Red Hill Bulk Fuel Storage Facility, O‘ahu, Hawai‘i
Defueling Plan Supplement 1.A
Department of Defense, September 7, 2022
Response to Requests for Information from DOH dated September 19, 2022

Diagram of trench system on Hotel Pier (green lines):

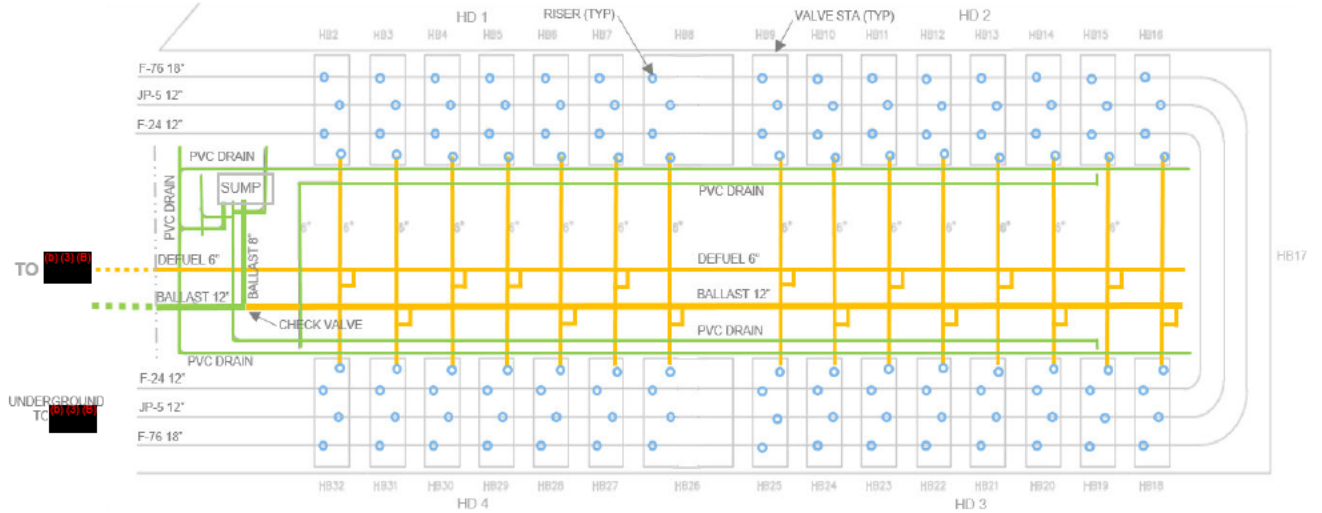
- 4. Page 6, Hotel Pier (HP- (b) (3) (B)): If Hotel Pier is used for unpacking, the Navy must show that the pipelines and trench can capture any fuel leaks or spills.**

Response: Photos and diagram below show Hotel Pier trench, which can capture and contain fuel spills and leaks. The concrete trench is currently used to capture rainwater which drains to the main sump for collection. If a spill were to occur, the fuel would collect into either a pipeline

trench drain or a pier stormwater trench drain, each connecting to their respective drain line that directs fluid to the Hotel Pier Sump. The Hotel Pier Sump is outfitted with sump pumps that are float actuated that transfer fluid to the FORFAC for reclamation.

Pipeline trench is outboard of yellow curb. Pier stormwater trench is inboard of yellow curb.

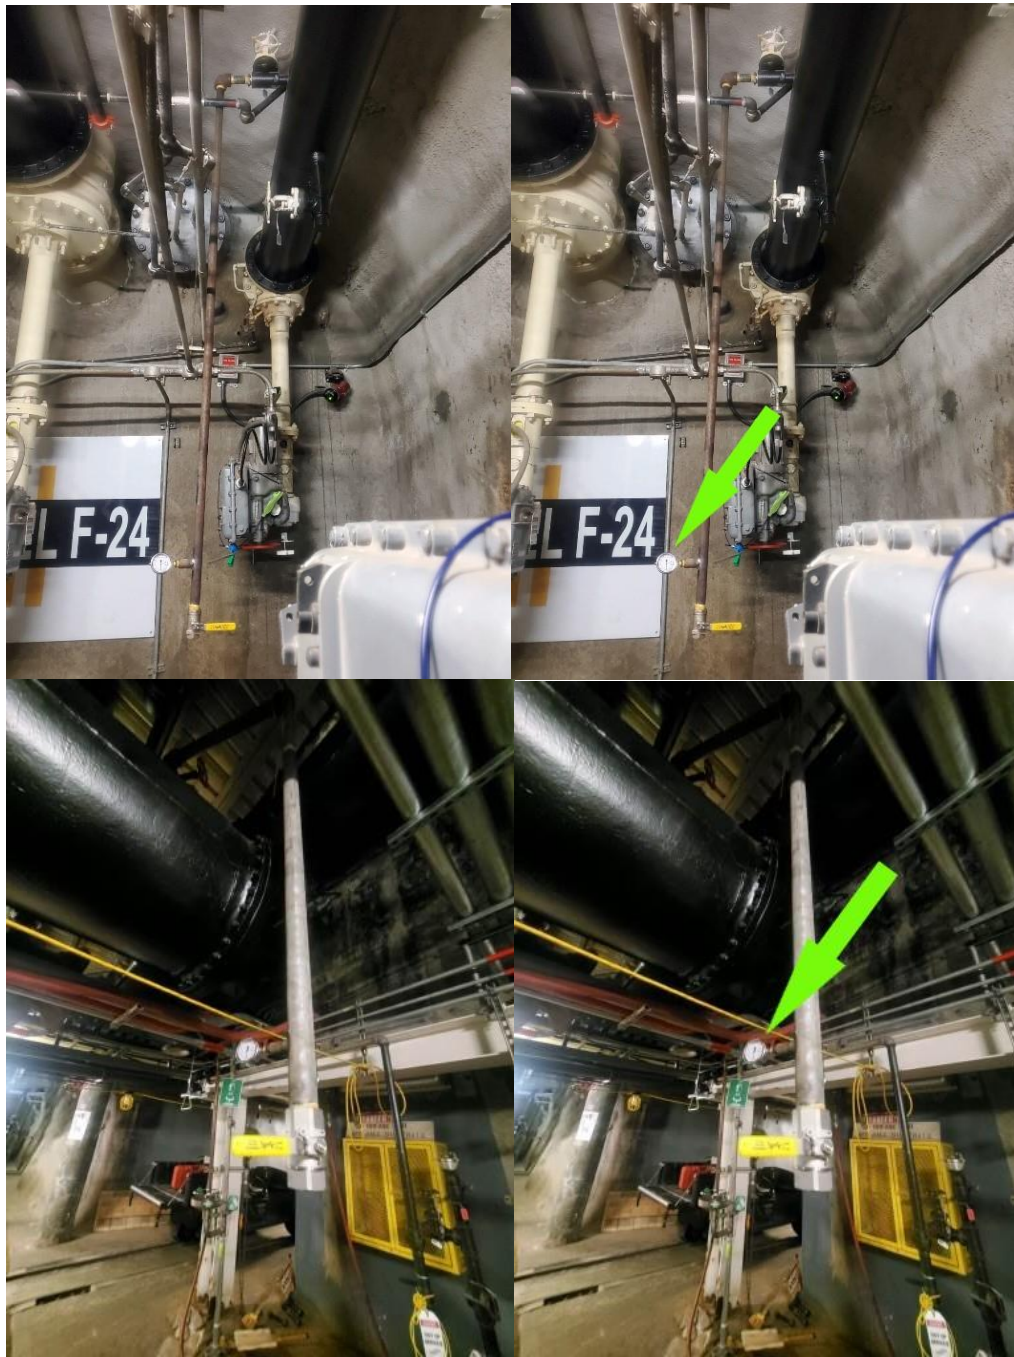
28. Page “RP-1,” RED PLAN: This page lists 7 facility personnel positions for the Control Room Operator to call, while the RH Spill Notification Call Tree diagram on Page “RP-5” shows the Fuel Control Room only calling the Regional Dispatch Center and Fuel Operations Director. Please clarify and explain the numbers listed before some of the caller/call recipient positions.

Response: Call tree numbers are listed on PDF page 45 of the spill exercise plan dated September 22, 2022. This information will be included in the Red Plan in the Facility Response Plan prior to defueling.
